Submission :DA_26016431 Construction of new and expanded substations, relocation and undergrounding of 275kV electricity transmission lines, and tree damaging activity

Development Number:	26016431		
Applicant:	ElectraNet and Australian Naval Infrastructure		
Nature of Development:	Construction of new and expanded substations, relocation and undergrounding of 275kV electricity transmission lines, and tree damaging activity		
Subject Land:	Mersey Rd N, Osborne & Pelican Point Rd, Outer Harbor – see application for details		
Contact Person:	Fiona Selleck	Phone Number:	7133 1754 / 1800 752 664
Close Date:	Tuesday 11 August 2026

Nature of Development: Construction of new and expanded substations, relocation and undergrounding of 275kV electricity transmission lines, and tree damaging activity

Figure 1: Comparison of URPS and Succession Ecology advice, from Facebook post by Alex Laratro

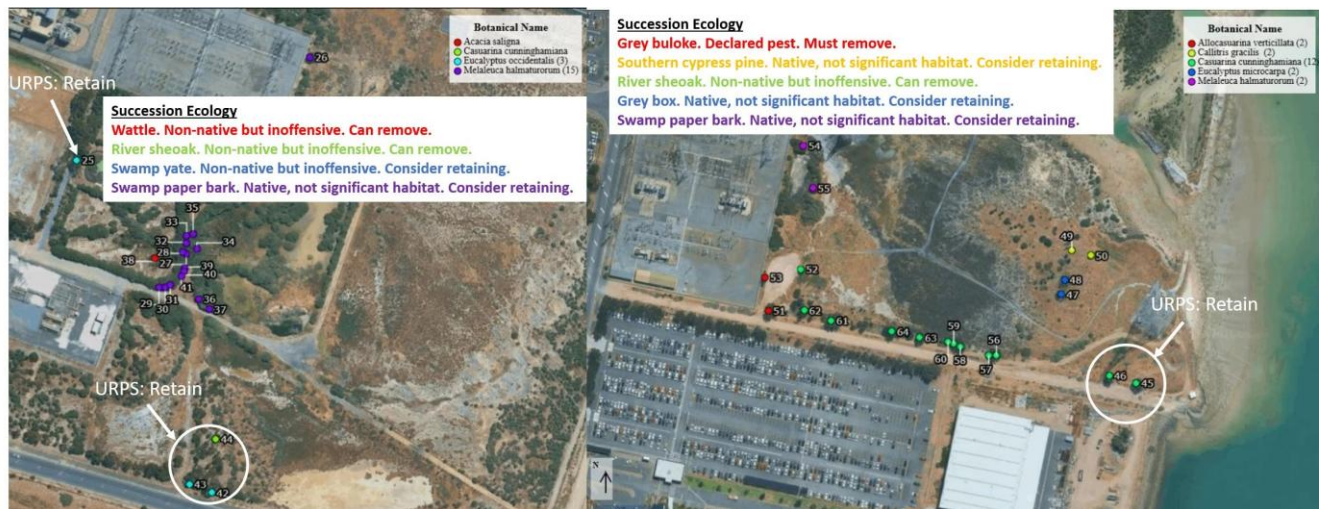
We were pleased that the Succession Ecology report was provided to SCAP so that we could consider their proposals for trees to be retained, compared to the advice from URPS.

ANI advise that ElectraNet have a dedicated budget for revegetation as part of their program and we suggest SCAP ask them to outline their plans and whether they will undertake replacement planting or pay into a relevant tree fund, and if so which one.

Figure 14: Existing vegetation south of SEA Gas pipeline

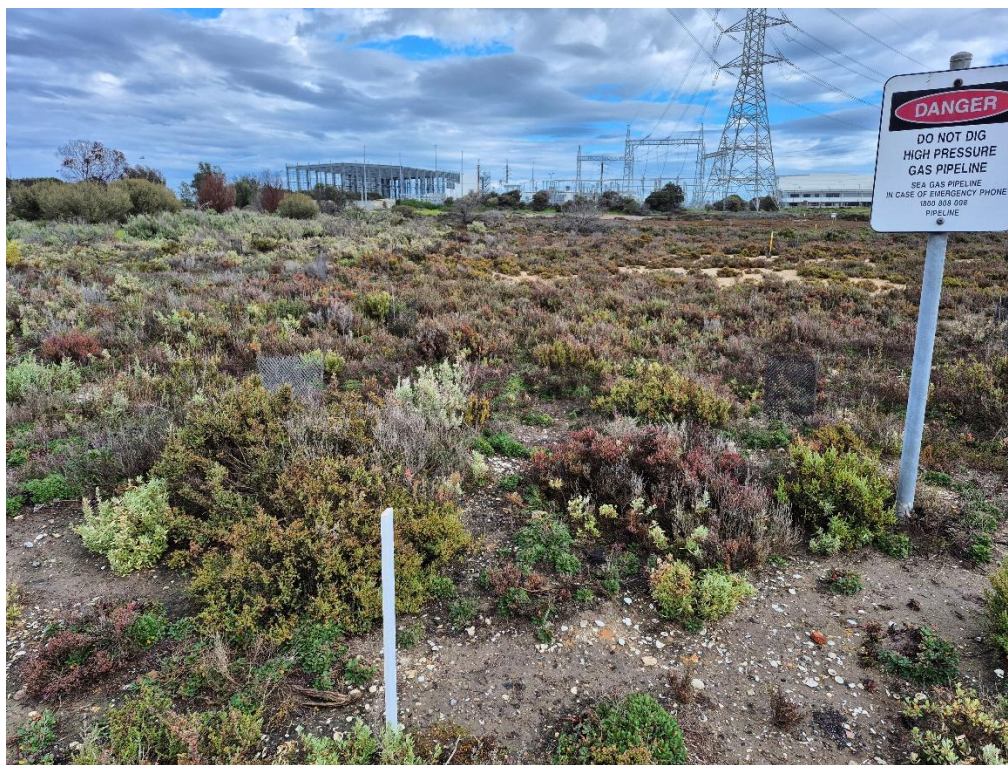
FPR suggest SCAP also needs to be advised about plans for any lay down area, and how it will be revegetated after the project. (Figure 14)
